Appendix 1:

Further information requested under Clause 23 First Schedule of the Resource Management Act 1991

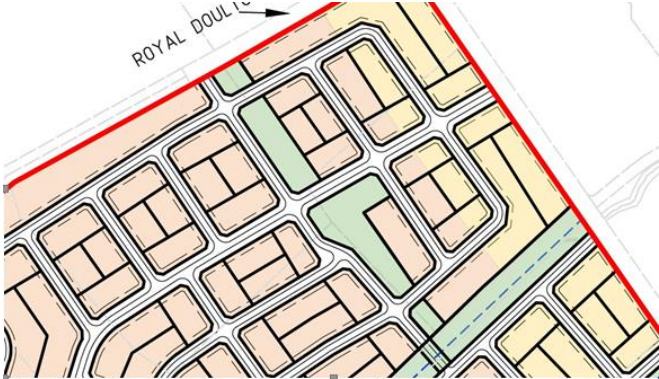
In relation to the indicative concept master plan the applicant is requested to explain:

- a) The rationale or purpose of the large open space illustrated in Figure 4 below, with limited access from the north. And why is this open space not proposed as a suburb park?
